dsPIC33CH128MP508 Family Silicon Errata and Data Sheet Clarification

The dsPIC33CH128MP508 family devices that you have received conform functionally to the current Device Data Sheet (DS70005319D), except for the anomalies described in this document.

FIGURE 1: I/O RAMP

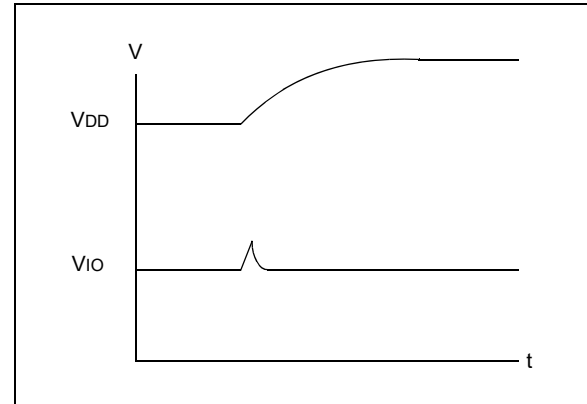
During a fast device power-up, when the V_{DD} ramp is less than 4 mS, the I/O pins may drive up to 100 μ A current for a duration of up to 10 μ S (Figure 1).

1. Slow down the V_{DD} ramp time (greater than 4 mS for V_{DD} to ramp 0V to 3.3V).
2. Ensure the circuitry that is connected to the pins can endure this pulse.

Example applications affected may include complementary power switches, where a transient current shoot-through might occur.

High-voltage applications with complementary switches should power the high-voltage 200 μ Sec later than powering the dsPIC[®] device to avoid the current shoot-through. This behavior is specific to each device and not affected by aging.
